Revolver

TECH NOTICE

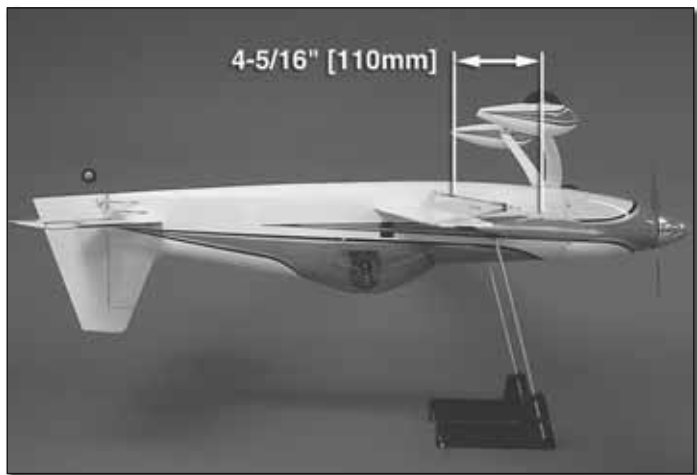
On page 26, “**Balance the Model**”, the text reads, “The C.G. is located 4-15/16” [110mm] back from the leading edge of the wing at the fuselage.” **This is the incorrect location of the C.G.** The C.G. should be 4-5/16” [110mm] as shown in the photo on page 27.
